July 29, 2021

Product Substitution Notice - In-Wall® Slide-out column clamps full length to 16"

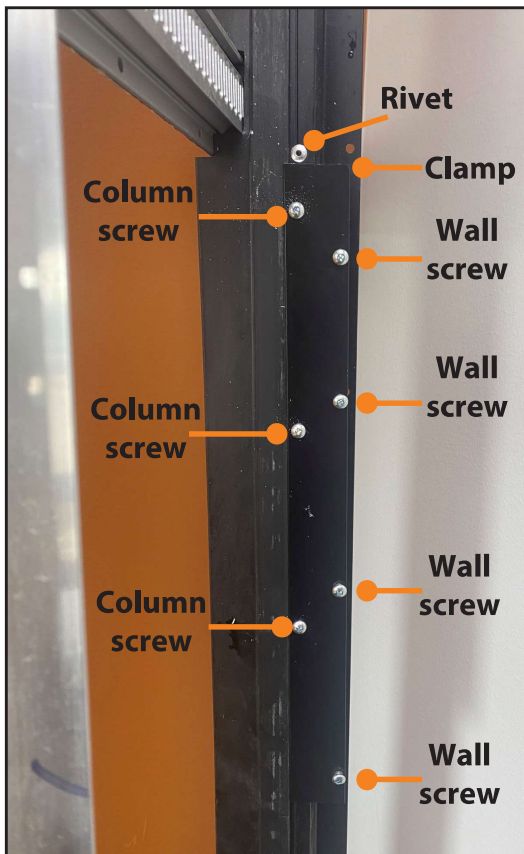
Please be advised, due to materials shortages Lippert intends to substitute all full length In-Wall Slide-Out inside clamps (two per system needed) with the universal 16" inside clamps (now four per system needed).

The full length clamps include PNs with the first six digits beginning in 389787, for example PN 389787711. The substitute 16" clamp PN is 7013241. Customers should order the clamps using the sub PN 7013241.

Fixed Top Clamp Position

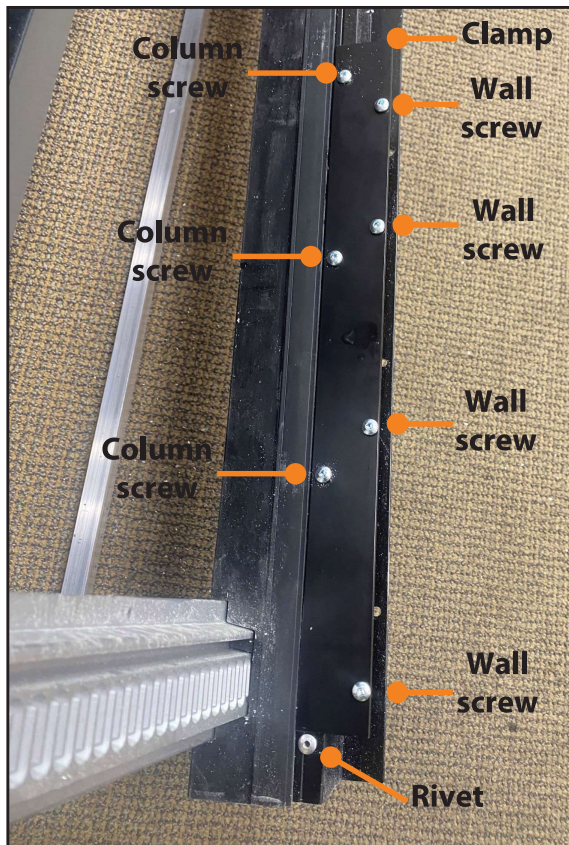
There are changes in installation for the OEM customer with the clamp substitution. The fixed side bottom and top 16" clamp correct positions are:

- Three holes screwed to the column.
- Four holes screwed to the wall opening edge, butted up against the edge of silver rivets and against the rubber seals edge on the column. The clamp will be below the silver rivet for top clamp position and above the silver rivet for bottom clamp position (see photos below).

The float side clamp installations will be a mirror image of the fixed side shown here.

Please note, any other orientation of the clamps or added screws could result in damage to the slide-out system. Please consult Lippert prior to doing either modification.
